Intersection ID: 11499	Main Street: TIMBERTOP_LN	Cross Street: VERONICA_DR	Location:	SE
ADA ID: C7D1A8C11A30	Ramp Type: BlendTrans1	Initial Pass/Fail: Fail	Overall Compliance: No	Severity Score: 10

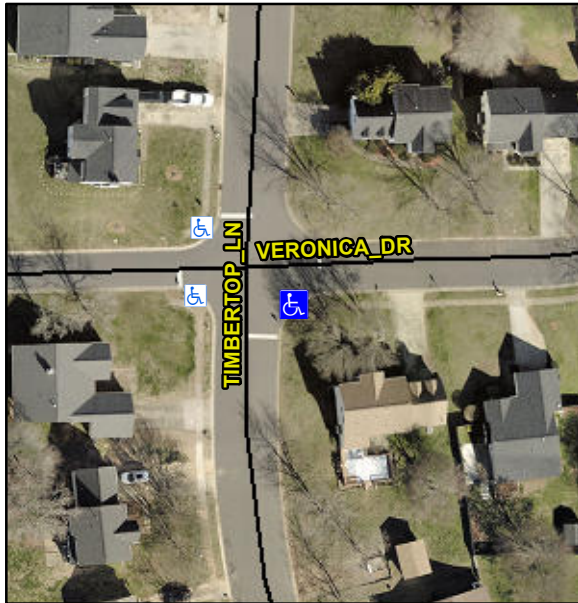
Not Found, R304.5.1, R304.5.3

Compliance	Description	Data	Compliance	Description	Data
N/A	Ramp Length (in)	95.0	Yes	BlendTrans Slope (%)	3.4
No	Ramp Width (in)	47.0	No	BlendTrans XSlope (%)	2.9
N/A	Flare Type LT	N/A	N/A	Flare Type RT	N/A
N/A	Flare Slope LT (%)	N/A	N/A	Flare Slope RT (%)	N/A
N/A	Flare Traversable LT?	N/A	N/A	Flare Traversable RT?	N/A
N/A	Landing Length (in)	N/A	N/A	DWS Provided?	N/A
N/A	Landing Width (in)	N/A	N/A	DWS Contrast?	N/A
N/A	Landing Slope (%)	N/A	N/A	DWS Length (in)	N/A
N/A	Landing X Slope (%)	N/A	N/A	DWS Full Width?	N/A
N/A	Landing Curb? (Y/N)	N/A	N/A	DWS Offset (in)	N/A
N/A	Shared Landing?	N/A			
N/A	Gutter Ponding?	N/A	N/A	Gutter Slope (%)	N/A
N/A	Gutter Lip Ht (in)	N/A	N/A	Gutter X Slope (%)	N/A
N/A	Painted X Walk1?	No	N/A	Painted X Walk2?	N/A
	X Walk 1 Direction	To W		X Walk 2 Direction	N/A
	X Walk 1 Width (in)	N/A		X Walk 2 Width (in)	N/A
	X Walk 1 Slope (%)	1.4		X Walk 2 Slope (%)	N/A
	X Walk 1 X Slope (%)	1.6		X Walk 2 X Slope (%)	N/A

N/A	Ramp inside XWalk1?	N/A	N/A	Ramp inside XWalk2?	N/A
	Road Slope (%)	1.6		Clear Space?	N/A
	Road X Slope (%)	1.4	N/A	Clear Space to XWalk (in)	N/A
N/A	Any Obstructions?	Yes	N/A	Storm Grate/Utility Hazard?	N/A
	Obstruction Type			Storm Grate/Utility Type	
GAS VALVE LIP 1.0					N/A
			Yes	Surface Condition? (G/P)	Good
			No	Curb Slope (%)	11.3

Remove & Replace Curb Ramp With Two New Directional Ramps or Equivalent.
